**Subject:** Submittal of Replacement Pages to Update the NAC-UMS<sup>®</sup> FSAR from Revision 4 to Revision 5 (Docket No. 72-1015)

**10 CFR 72.48 Evaluation Summary Report**

**NAC-UMS<sup>®</sup> Universal Storage System  
(Docket No. 72-1015)**

OUTER HOOPS AND VERTICALS  
AND VENT REINFORCEMENT  
REBAR SHOWN IN SEPARATE VIEWS FOR CLARITY

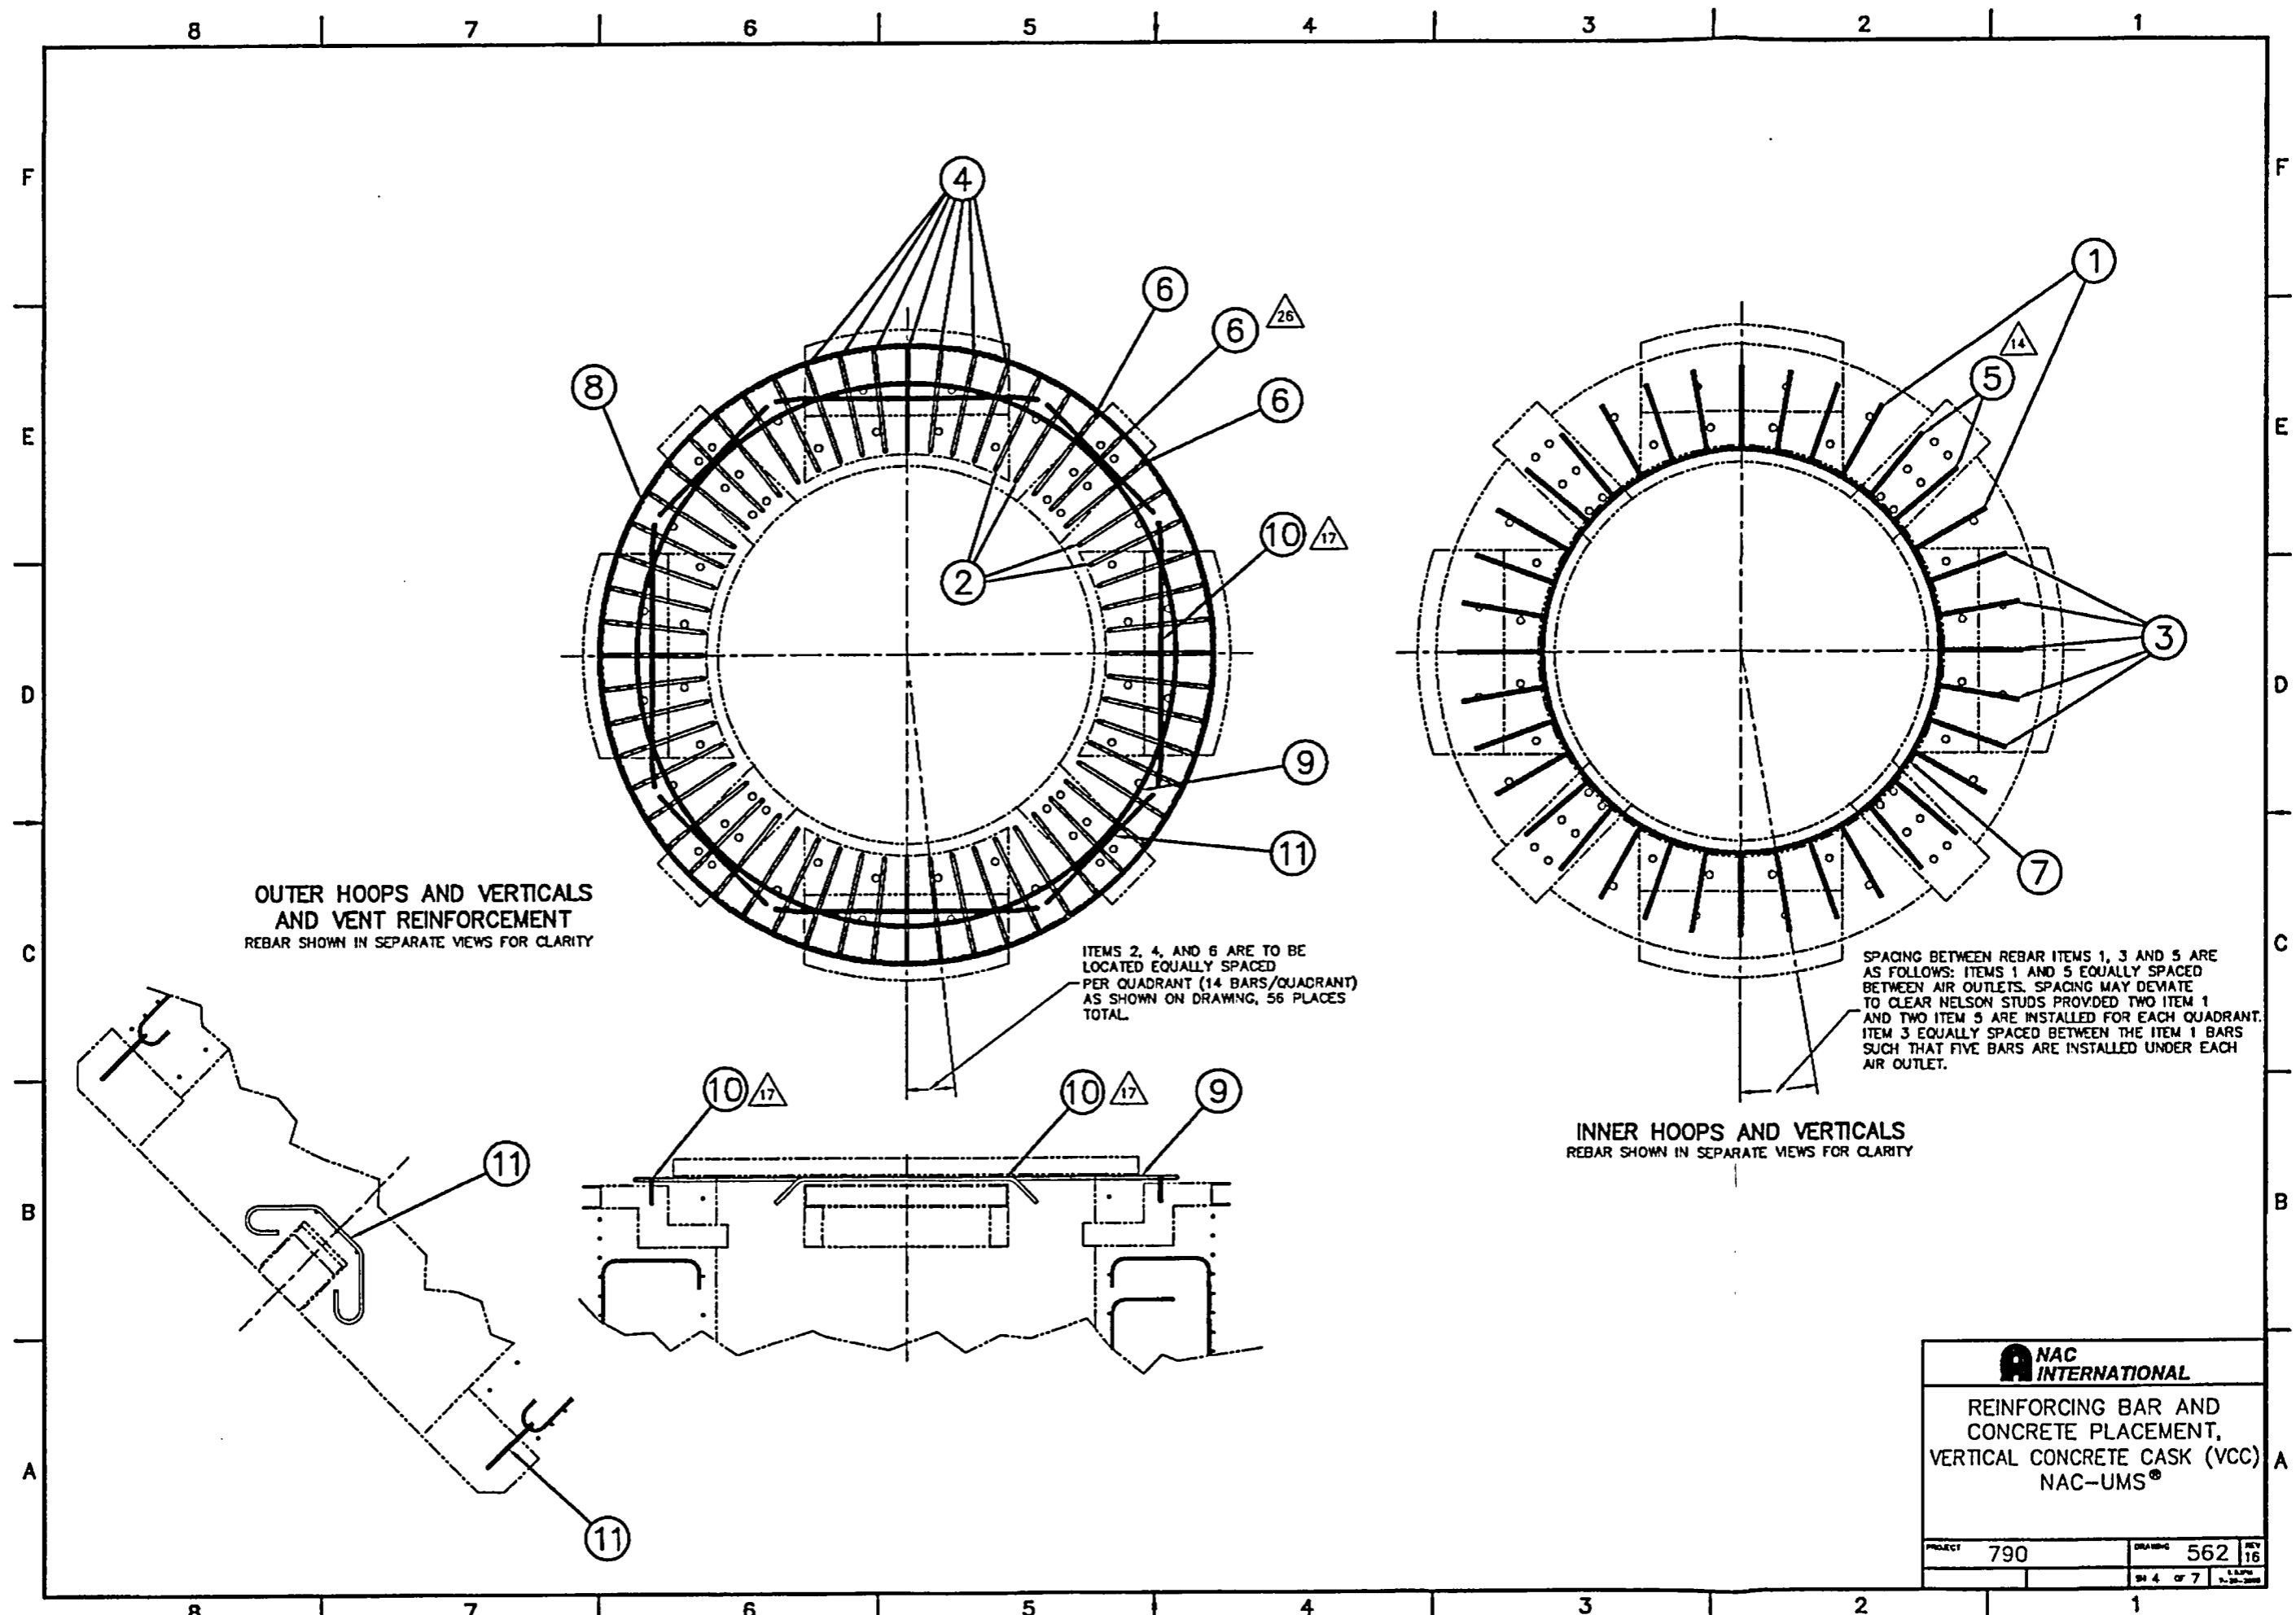
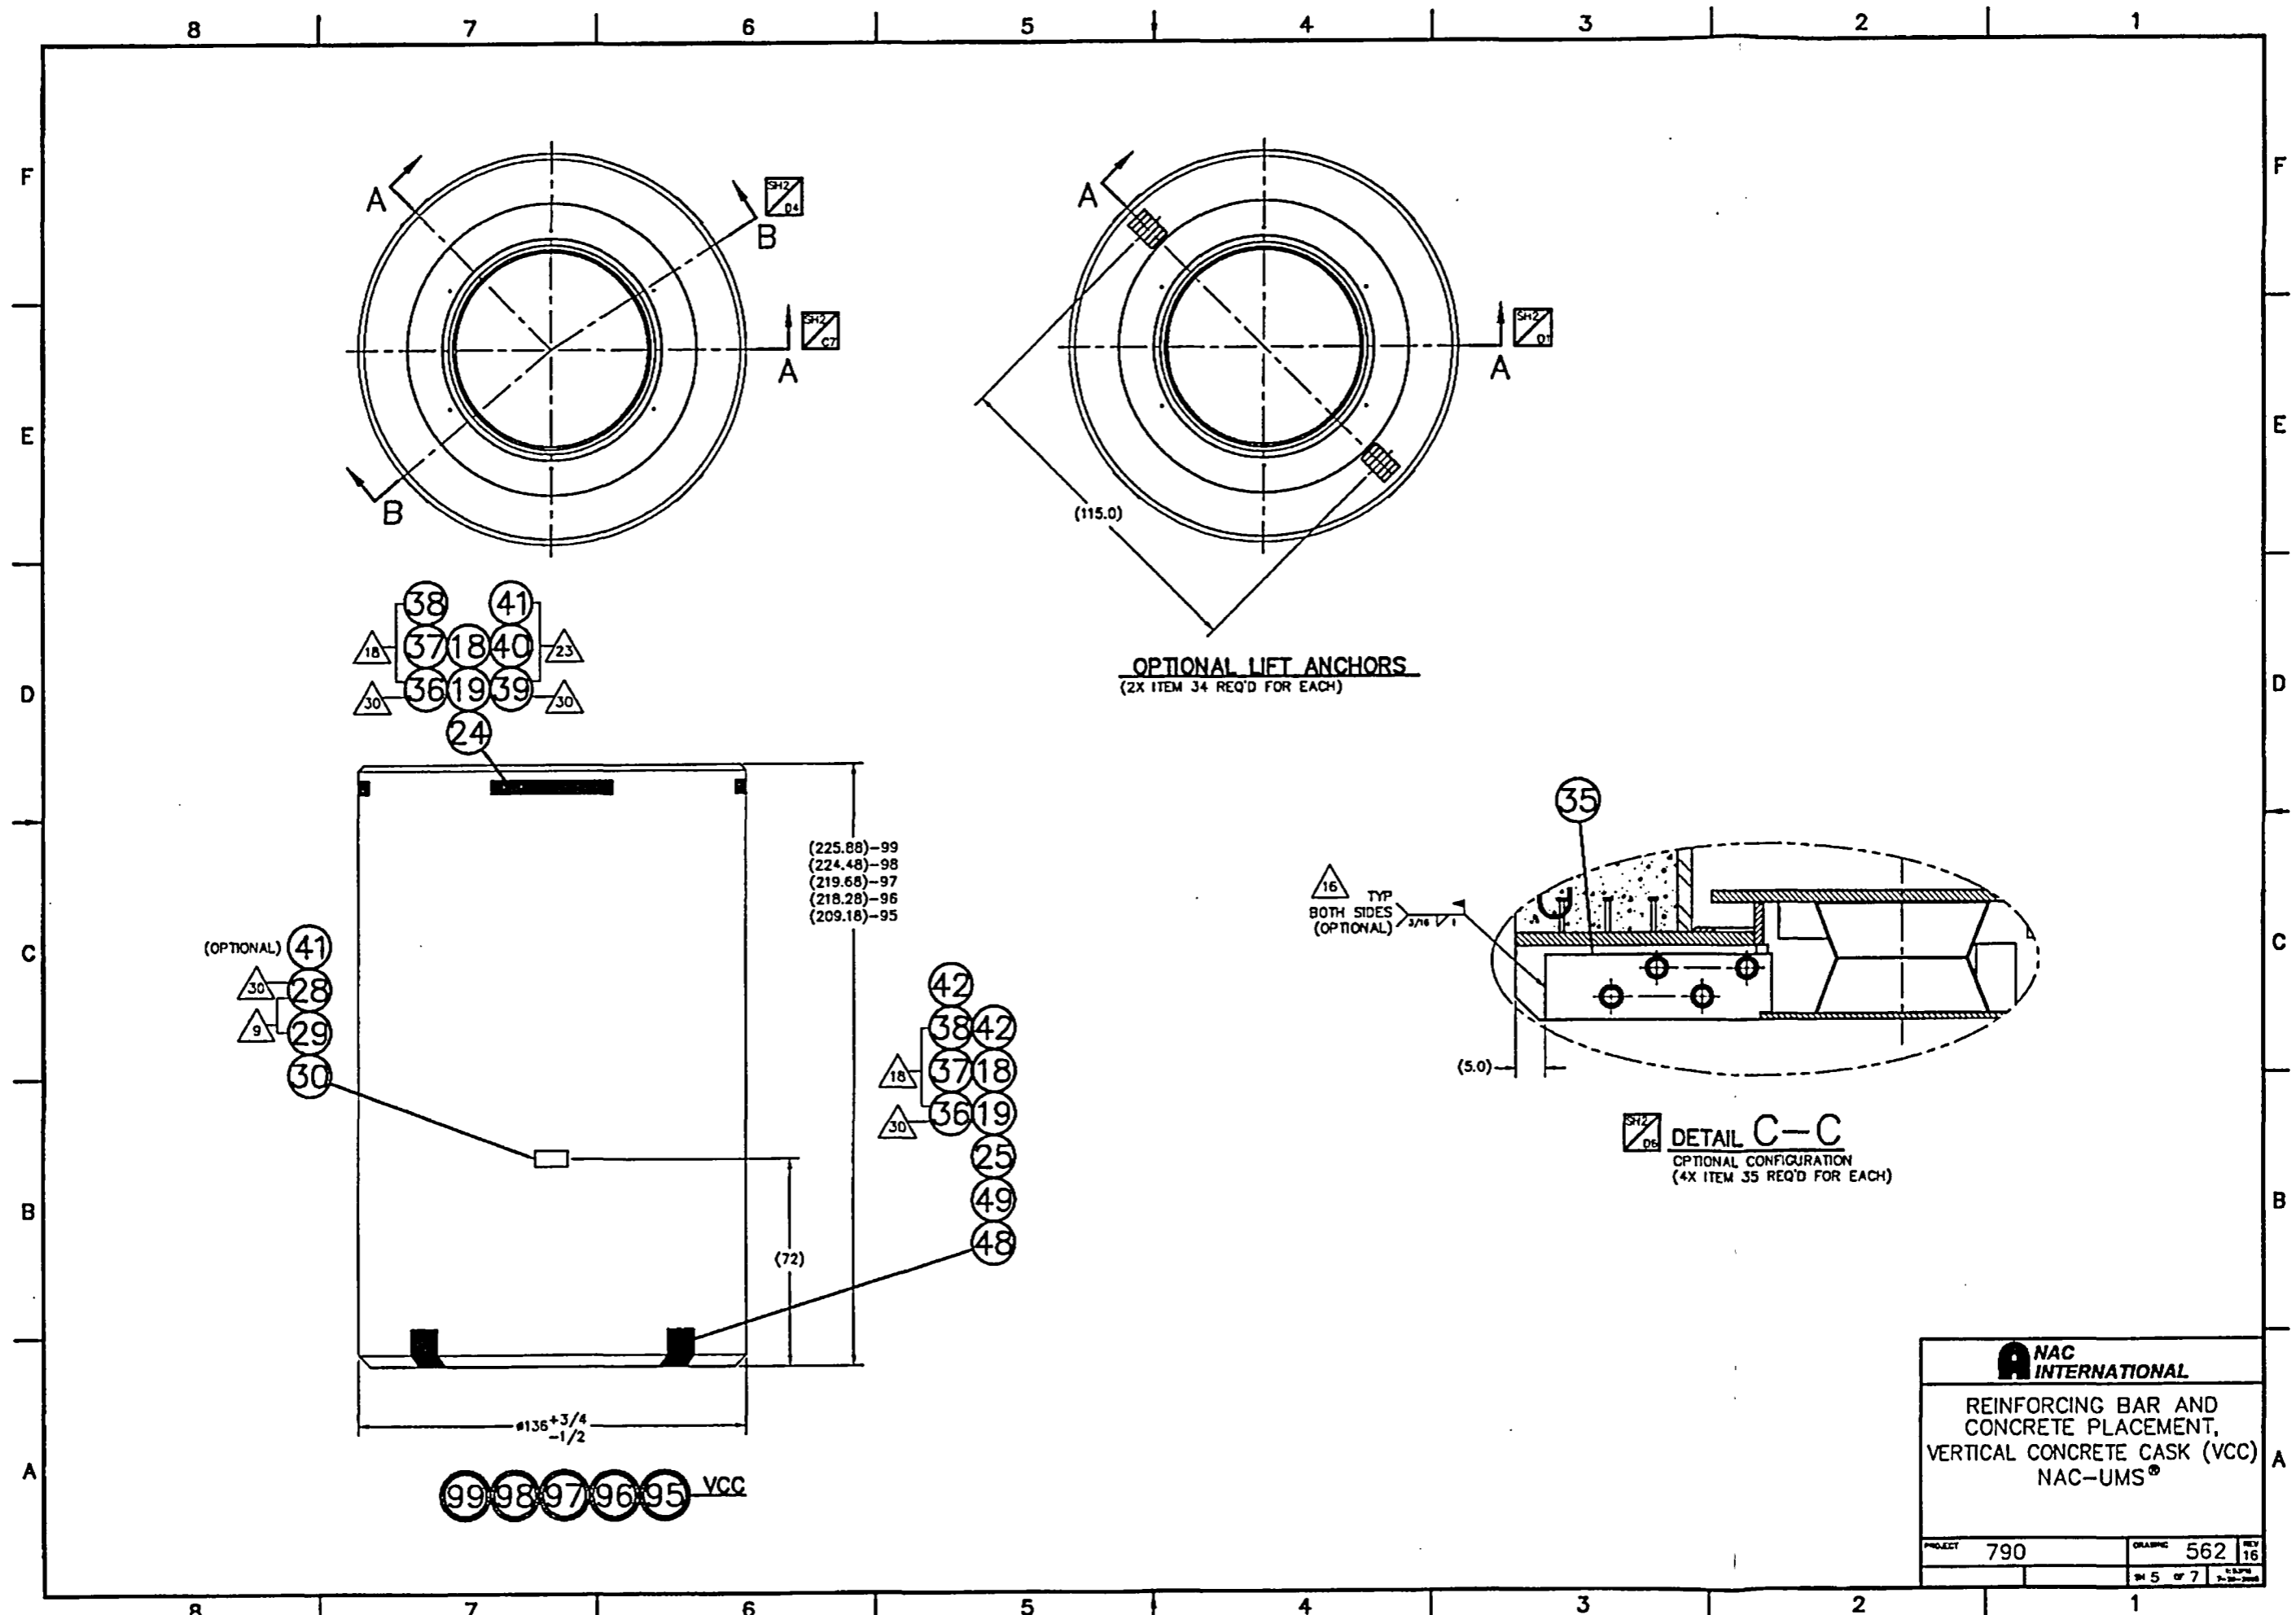
Revision 15 of Drawing 790-562 adds an “Optional Drain Hole (one per quadrant)” to the side of the inlet opening, in Section B-B.

Revision 16 of Drawing 790-562 changes Item 48, Retainer Plate, Alternate Fabrication-A (Sht 7 of 7, Zone D-6).

This drain hole will provide a path for water drainage in the cavity formed by the vertical concrete cask bottom plate, inlet sides, shell liner, stand, and the shield ring. The addition of this feature (a drain hole in the side of the air inlet) is insignificant as related to the structural and shielding calculations and will not affect the form, fit or function of the Base Weldment and/or other vertical concrete cask components.

This change will allow the concrete anchor and anchor mounting hole to be moved away from the edge of the concrete (near the side of the inlet tunnel). If the mounting hole is too close the edge of the concrete, the thin wall section of concrete between the mounting hole and inlet weldment crumbles. This results in the need to glue the anchor in place with an adhesive product and repair the crumbled concrete.
